AUG 25 2011
L-2011-334
10 CFR 50.90

Re: Turkey Point Units 3 and 4
Docket Nos. 50-250 and 50-251
Response to NRC Request for Additional Information Regarding
Extended Power Uprate License Amendment Request No. 205 and
Reactor Systems Issues

Turkey Point Units 3 and 4
RESPONSE TO NRC RAI REGARDING EPU LAR NO. 205
AND SRXB REACTOR SYSTEMS ISSUES

2.8.5.1.2 Steam System Piping Failures Inside and Outside Containment

Figure SRXB-LR 2.8.5.1.2J-1
Steam System Piping Failure at Hot Zero Power – 0.9 ft² Split Break
with Offsite Power Available and with Accumulator Boron Credited
Nuclear Power and Core Heat Flux vs. Time

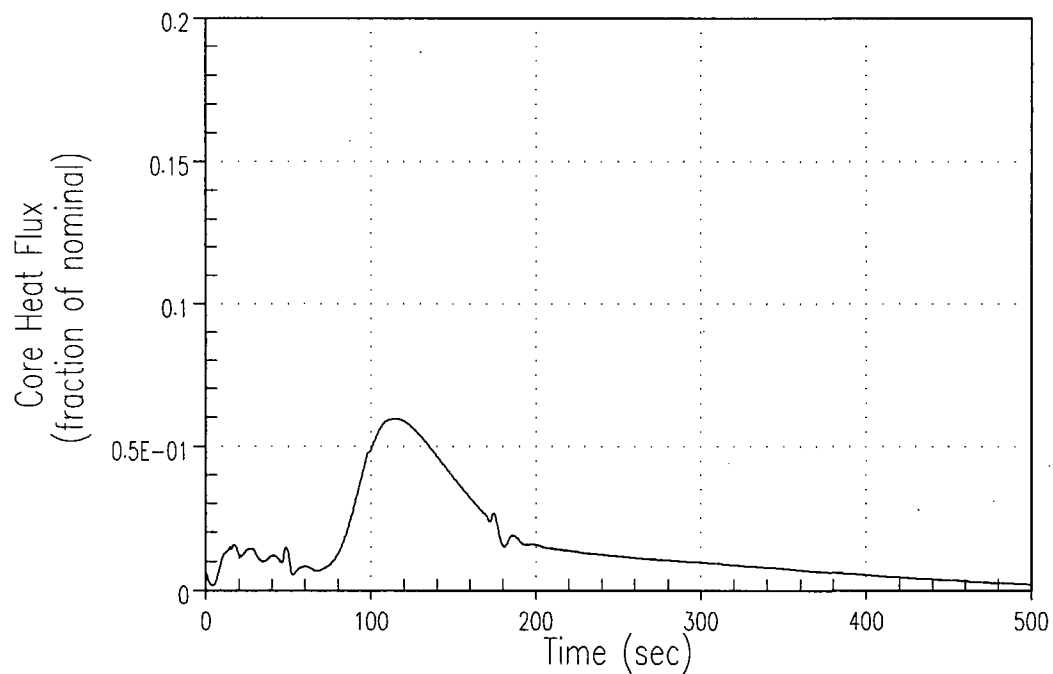
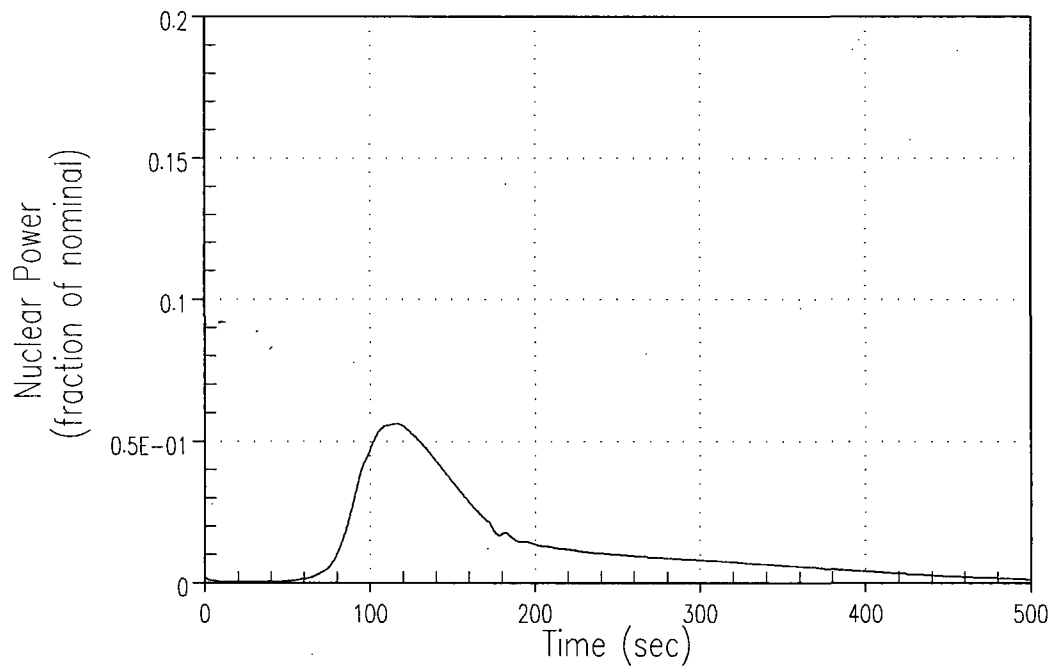
2.8.5.1.2J Minor steam line breaks ($< 1.4 \text{ ft}^2$) are said to be bounded by the major steam line break. Show that there is no minor break, larger than a credible break; but too small to cause steam line isolation, that is not bounded by the major steam line break.

A comparison of the sequence of events for each of the analysis cases examined is provided in Table SRXB-LR 2.8.5.1.2J-2; the transient plots for the analysis of a 0.9 ft² split break on the main steamline with minimum accumulator boron credited are provided in Figures SRXB-LR 2.8.5.1.2J-1 through SRXB-LR 2.8.5.1.2J-8.
